DA NO: DA-2023/281
ADDRESS: 39 THE SCARP, CASTLECRAG NSW 2068
PROPOSAL: CONSTRUCTION OF A NEW DWELLING HOUSE, SECONDARY DWELLING, WORKSHOP, TREE REMOVAL, DETACHED CARPORT, CAR CROSSING LANDSCAPING AND ASSOCIATED WORKS.
RECOMMENDATION: DEFERRED COMMENCEMENT CONSENT
ATTACHMENTS:

RESPONSIBLE OFFICER: RITU SHANKAR – TEAM LEADER
AUTHOR: OLIVIA NAVRATIL – ASSESSING OFFICER
REPORT DATE: 12 DECEMBER 2024
REPORT FOR: ELECTRONIC DETERMINATION

ATTACHMENT 1: SUPPLEMENTARY ASSESSMENT

An extract of the three (3) west side setback scenario's is shown below:

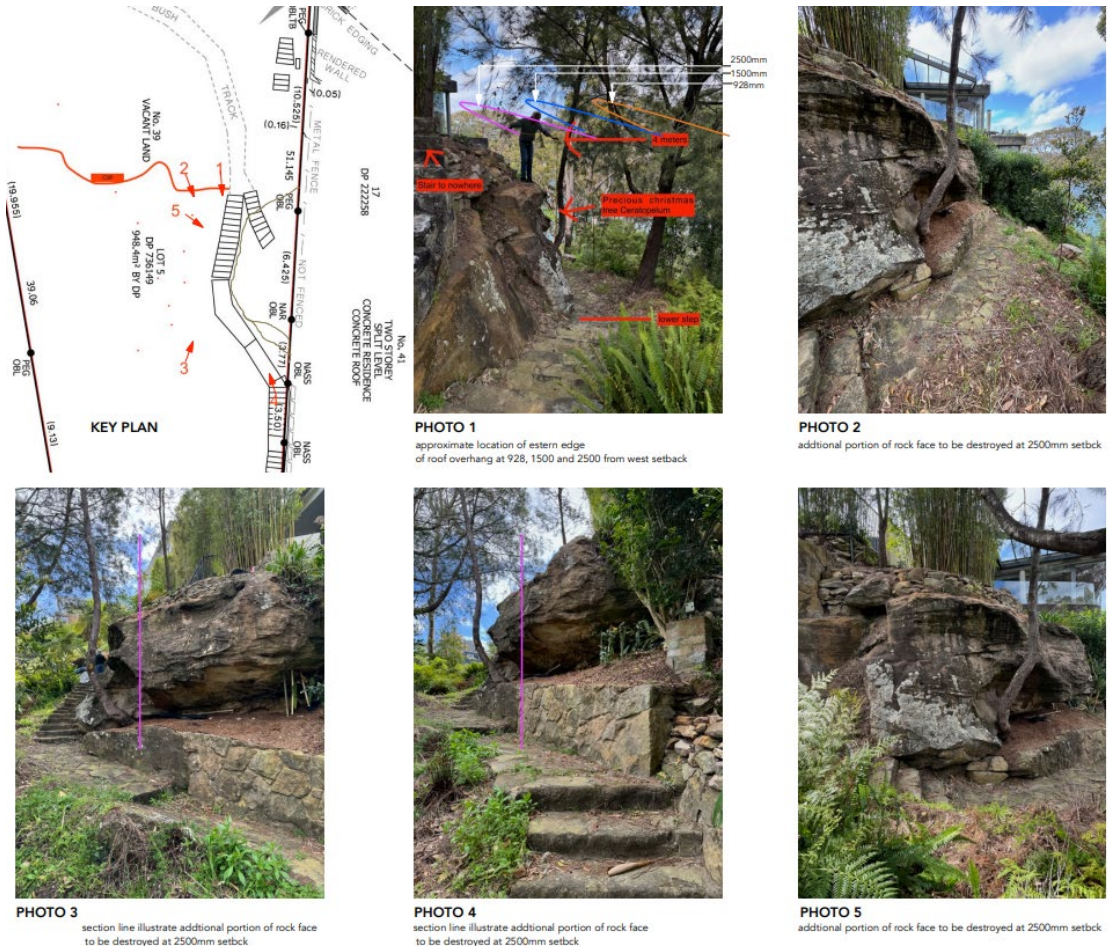
1. The 0.9m west side setback (identified by the red line) was the original side setback and the preference of the applicant. This option would result in a built form that is in close proximity to No.37 The Scarp and in a manner that would result in a 40% breach to the minimum side setback control which is not supported by Council.

2. Amended plans submitted with the application and dated 24 September 2024 indicated a 1.5m west side setback (identified by the black line/building as shown) to comply with the ground floor side setback controls under the *WDCP 2023* and was supported by Council as part of the recommendation to the WLPP on 3 December 2024. In particular, support of the 1.5m option considers the following:

3. The 2.5m west side setback (indicated by the pink line) demonstrates the option for an increased side setback in response to the panel’s request for further investigation following the WLPP meeting on 3 December 2024. This option results in the excavation of rock outcrop which does not ensure the preservation of natural features as required by the *WDCP* and is not supported by Council. In particular, the applicant has prepared an extract to visually demonstrate the rock outcrop that would be impacted as a result of an increased side setback which is shown below:

Having regard to the above, the 0.9m west side setback option and the 2.5m side setback options are not supported due to the adverse impacts to No.37 The Scarp and/or to natural features. Council supports the applicant’s 1.5m west side setback scenario for the ground floor of the principal dwelling as it would reasonably manage the site constraints, minimise adverse impacts to adjoining properties and ensure the preservation of natural features so as to respond to the constraints of the site.

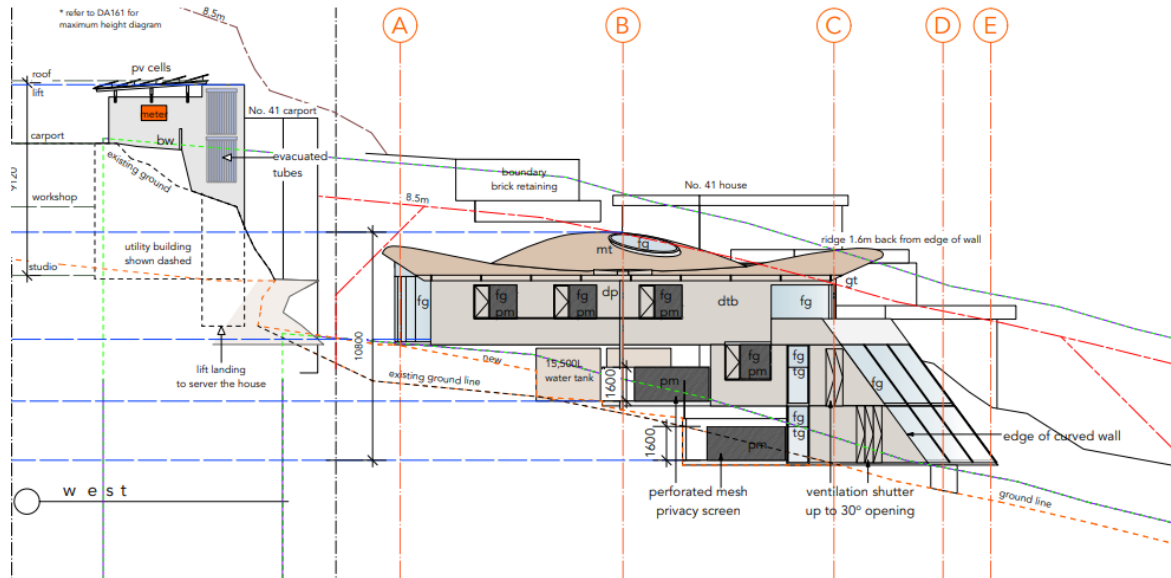
The applicant proposes textured glazing in combination with perforated screen to ensure 2-way privacy and indicates that the drawings dated 6 December 2024 communicated the conscious management of 2-way privacy. The West Elevation dated 6 December 2024 is shown below:

This is considered acceptable and a condition of consent can be applied to ensure the carrying out of privacy measures and ensuring that these are maintained in perpetuity.

Note: The green hatched area is the only part of the ground floor balcony that is >4m above EGL and setback less than 6m from the boundary facing No.37 The Scarp.

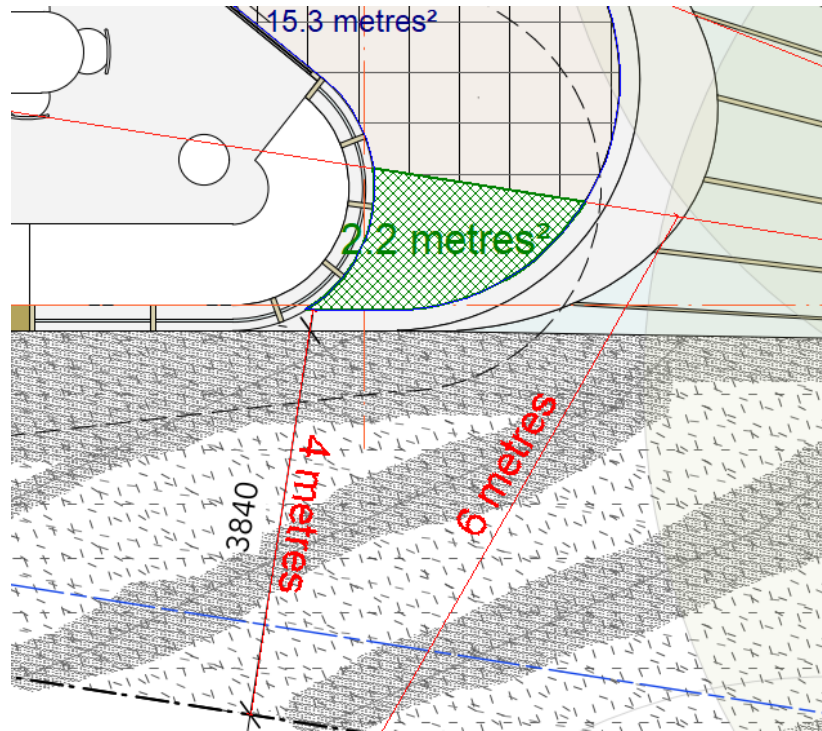
component of the balcony and is not considered to impose an adverse impact, subject to conditions. In particular, privacy screening and perpetuity conditions can be imposed to ensure the visual and acoustic protection of No.37 The Scarp.		
--	--	-----------------------------------------------------------------------------------------------------------------------------------------------------------------------------------------------------------------------------------------------	--	--

Figure 1: Section demonstrating the exceedance of the building height control applying to the proposed dwelling (Source: Peter Stutchbury Architecture)

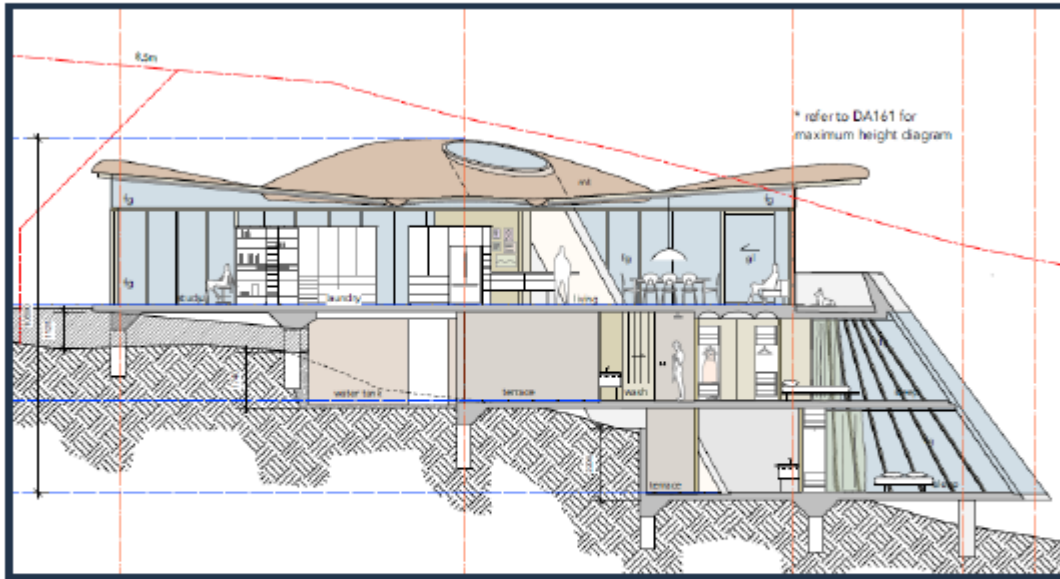
As set out above in the justification from Peter Stutchbury Architecture, the principal reason for the exceedance of the maximum building height limit is designing the development to best respond to the topography of the site. The proposed sections provided in **Figures 1** below demonstrate the sloping topography of the site and the minor exceedance of the building height controls.

In light of the prevalent form of development in the area where elevated and projecting balconies can be found, the contravention is considered to be minor given it relates to a minor and non-accessible portion of a roof that creates visual interest within the site. A full assessment of the proposed variations has been undertaken to demonstrate the development standard is unreasonable or unnecessary in this instance and there are sufficient environmental planning grounds to justify the contravention. Despite the proposal's proposed variation to the development height standard, the development is considered to represent a superior design outcome, as set out in this Clause 4.6 Variation Request document.
